[Docket No. NHTSA-2009-0002]

Anthropomorphic Test Devices; SID-IIs Side Impact Crash Test Dummy; 5th Percentile Adult Female

ACTION: Final rule, response to petitions for reconsideration, technical amendment.

Figure 1: Alignment of iliac wing, backer plate, and load cell/replacement¹⁶

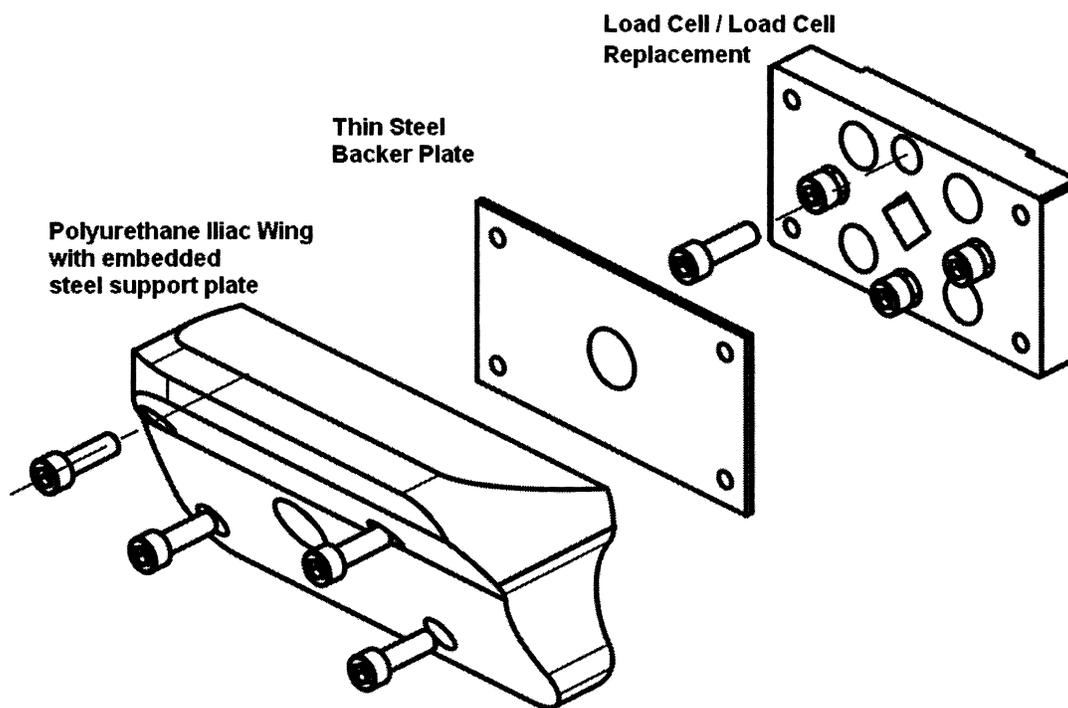
In response to the final rule, FTSS noted that, in general, the iliac wing specified in the final rule has the

propensity to cause a load path short due to its design. According to FTSS, the original iliac wing design resulted in 1/8-inch polyurethane material being sandwiched between the embedded iliac wing support plate and the iliac load cell. It found that the amount of loading force the iliac is able to accurately measure can vary depending upon how much torque the iliac mounting screws are under, how much the polyurethane material creeps over time, and how much the iliac maintains its original shape.

FTSS stated that it has designed a new iliac substructure (support plate) that has a positive bearing surface contact between the iliac wing and the load cell to create a rigid mounting surface between the iliac wing and load cell.¹⁷ Essentially, the 1/8-inch thick polyurethane material around the mounting screw holes was replaced with 1/8-inch thick steel “standoffs” that extend from the embedded plate to the edge of the wing so that the mounting screws would draw the iliac wing to the load cell through a metal contact instead of through polyurethane. According to FTSS, this design eliminated the

potential for load path shorting since standard fastener torque values can now be specified for the iliac wing mounting hardware without losing the torque over time, and it also eliminated the material creep found in the original iliac design. FTSS recommended that NHTSA evaluate this new design and include it in the drawing package in place of the original.

artificially low measurements.” It stated, however, that while the use of the thin steel backer plate specified in the final rule (as shown in Figure 1) will reduce the likelihood of off-loading the load cell, it will not reduce deformation of the polyurethane iliac wing. It suggested that a more robust solution would be to use a rigid steel plate with standoffs that are embedded in the polyurethane iliac wing during manufacturing. The Alliance stated that “this stronger plate with standoffs eliminates the possibility of off-axis loading.”

plate between the wing and load cell, as specified by the final rule (Table 2). VRTC found that qualification test results from these two iliac configurations were very similar. The average response from wings without a backer plate was always lower than that from wings with a backer plate as seen in Table 2, but was also always less than a 2.5% reduction from the response with a plate.²⁰ Thus, the influence of the backer plate appears to be negligible. However, the plate can act to prevent load path shorting through wing contact with the center of the load cell. Although there were no instances of load path shorting during qualification tests without a plate, two quasi-static tests without a backer plate were conducted on both the softest and stiffest M3 iliac wings with standoffs. In this set of tests, the softest iliac wing made contact with the center of the load cell at a load of about 3,700 N (831.8 lb). To prevent this from happening, we have decided to retain use of the thin steel backer plate between the iliac wing and iliac load cell.

Figure 2: Examples of pelvis-acetabulum, pelvis Y acceleration response traces

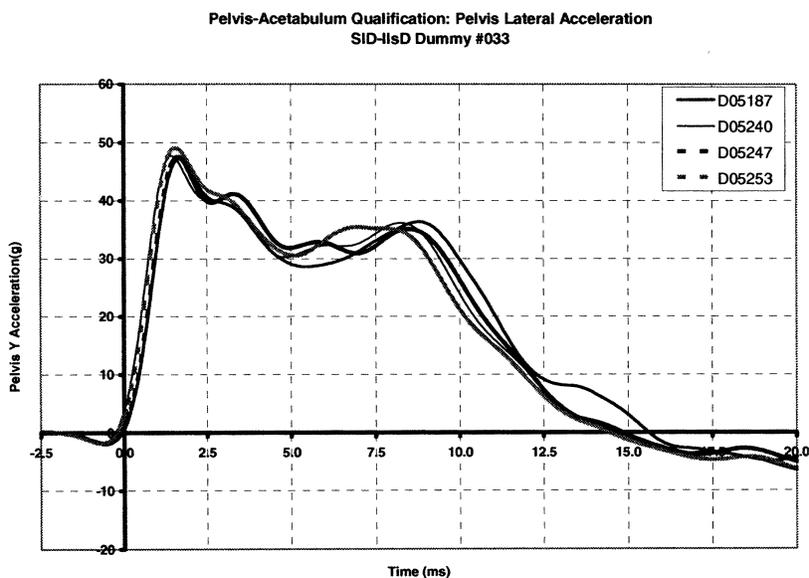
Denton/SAE DTES recommended removing the pelvis lateral acceleration requirement from the test due to what was believed to be a large variability of response. An attachment to the petitioner's submission stated that a member of the SAE DTES presented pelvis lateral acceleration data from three different laboratories where the data looked distinctly different. It was noted in the attachment that the shape of the pelvis lateral acceleration peak varied widely, even with a single dummy in one lab. The DTES discussed possible reasons for the high variability of the first peak, but were not able to discern a definite explanation for this behavior. Although they agreed that variability was reduced when the acceleration peak was taken after 5 ms, they did not think that the measurement was necessary for qualification of the dummy and therefore recommended that the peak pelvis lateral acceleration be dropped. Alternatively (as seen in the next section), if the pelvis lateral acceleration parameter were not dropped, Denton/SAE DTES recommended to take the peak after 5 ms to eliminate the variable first peak.

section, the first peak of the pelvis lateral acceleration response, which occurs in the first 5–6 ms, is based primarily on the plug response. Since the pelvis-acetabulum test aims to verify the pelvis response, not the plug response, the acceleration during the first 5–6 ms should not be included. However, NHTSA examined pelvis lateral acceleration traces in 11 side impact crash tests conducted with the SID-II's Build Level D dummy to determine if the first peak, which results from initial pelvis plug crush in qualification tests, was part of the dummy response in vehicle tests. (If the first peak were part of the dummy response, we would be disinclined to disregard this peak in dummy qualification.) Crash test results showed generally unimodal pelvis Y accelerations, indicating that in vehicle tests, the initial plug crush does not play a significant role in the results.

To determine after what point in time the peak lateral pelvis acceleration should be taken, NHTSA analyzed pelvis lateral acceleration traces for 46 pelvis-acetabulum qualification tests from four dummies and two labs. The data clearly showed multiple, distinct peaks as seen in Figure 2. As mentioned previously, the first main peak and second small "bump" in the data are due to the pendulum impacting the pelvis plug and (most likely) the pelvis flesh, respectively. The second major peak (called the "second peak" henceforth) represents the response of the dummy after the leg mass comes into play, and is the measure of interest for qualification of the dummy. As the petitioners claimed, the first peak was consistently higher than the second peak. In order to prevent measuring this first, less meaningful peak for qualification, the petitioners recommended that the peak pelvis acceleration value be taken after 5 ms after probe contact with the dummy.

Figure 3: Pelvis Y acceleration traces (with the exception of D05149) with main response peak values lower than the acceleration at 5 ms

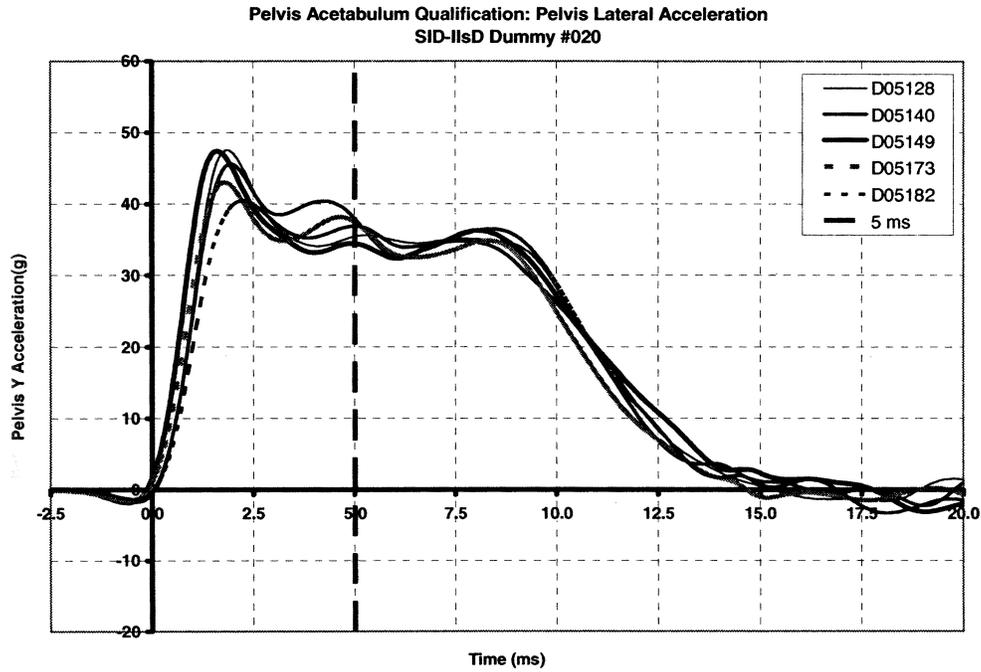
It was not clear from the data that 5 ms was the most appropriate time to begin measuring a peak value. For each of these 46 traces, the peak values after 5 ms, 6 ms and 7 ms were obtained in order to determine how much time after probe impact should be disregarded to prevent the first peak from being measured. It was found that in five of the 46 tests, the maximum value after 5 ms was higher than that after 6 or 7 ms, because the value of the decreasing “first peak” response at 5 ms was higher than the main dummy response peak value. Four of these 5 instances occurred in Dummy S/N 20, and are seen in Figure 3 below. These cases led the agency to determine that the peak should be taken after 6 ms. However, in

two tests, the peak of the main dummy response occurred just before 6 ms (see Figure 4), causing the peak after 6 ms to be slightly less than the actual peak. This occurrence was rare, though, and only resulted in an error of approximately 0.1 g for both tests. As a result of this evaluation, this final rule specifies that the peak pelvis lateral acceleration be taken after 6 ms.

Figure 5: Peak shoulder deflections generated at probe impact velocities of 4.2 – 4.5 m/s

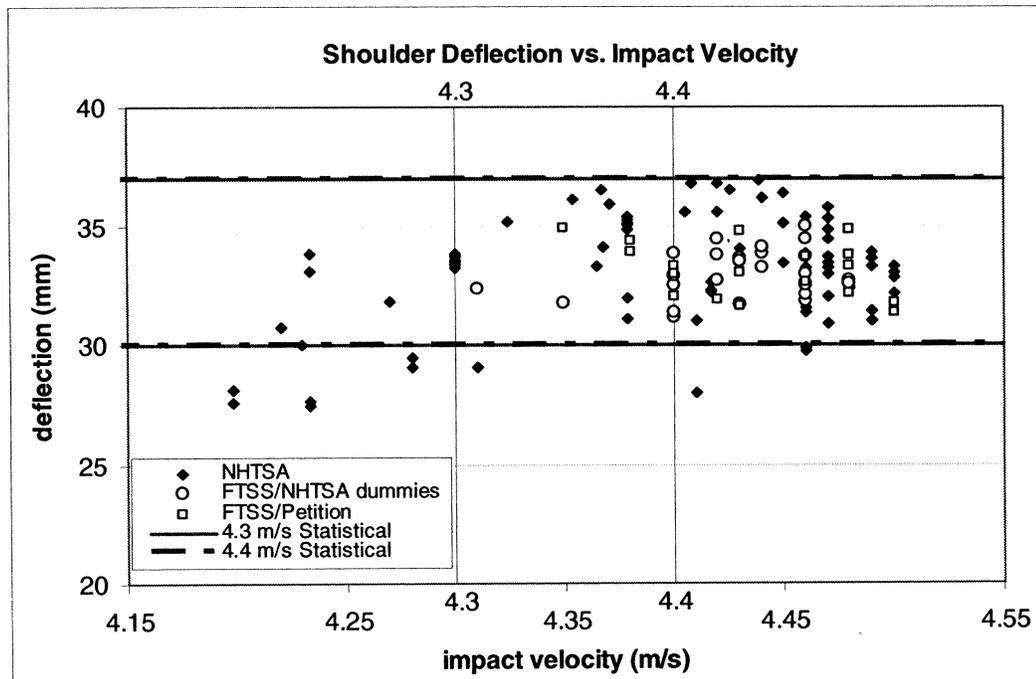
To support its petition, the Alliance also made the argument that the impact velocity should be reduced to 4.3 ± 0.1 m/s because the average shoulder deflections in agency crash tests are lower than those resulting from qualification tests. This is true; the average shoulder deflections in agency crash tests were somewhat lower than the average deflections in qualification tests (shown in Table 3). However, we do not agree that it is necessary for the average shoulder deflections in qualification tests to align precisely with the average deflection in crash tests. This is due to the large variations in crash test shoulder deflection measurements³² as compared to the relative closeness of shoulder deflection responses at a 4.3 ± 0.1 m/s vs. 4.4 ± 0.1 m/s impact velocity. Additionally, the agency usually establishes qualification tests to exercise dummy components at the level of the IARV, not at the level of the average recorded measurement in a crash test. Here, however, since there

Figure 5 shows the peak shoulder deflection responses with respect to the impact speed of the pendulum. It is observed that the peak deflections are noticeably lower at impact speeds of approximately 4.2 m/s. Because of this observation, the qualification performance corridors have been formed with the mindset that the statistical corridor (which is centered at the mean

of the data set) may have to be adjusted to accommodate low deflections at the low impact velocities, since the mean of the 4.2–4.4 m/s data set may be slightly high due to the majority of tests being conducted between 4.3–4.4 m/s. The revised corridors are discussed in “Analysis and Development of SID–II’sD Qualification Specifications in Response to Petitions for Reconsideration (July 1,

2008),”³¹ and in section XI.a of this preamble. We believe that by adjusting the performance corridor to reflect deflection responses at lower impact velocities, the new performance corridor will satisfactorily represent dummy responses over the full range of the revised specified impact velocities.

**FIGURE V4-A
SHOULDER IMPACT**

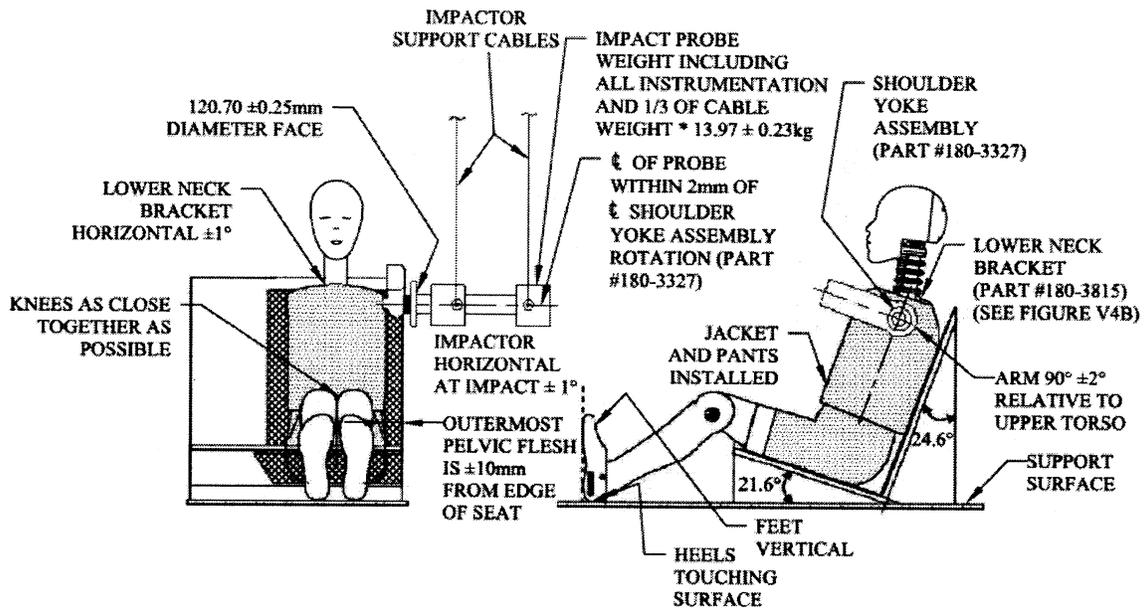
■ 13. Figures V4-A, V9-A and V9-B in "Appendix A to Subpart V of Part 572-Figures" are revised to read as follows:

* 1/3 OF CABLE WEIGHT NOT TO EXCEED 5% OF THE TOTAL IMPACTOR PROBE WEIGHT
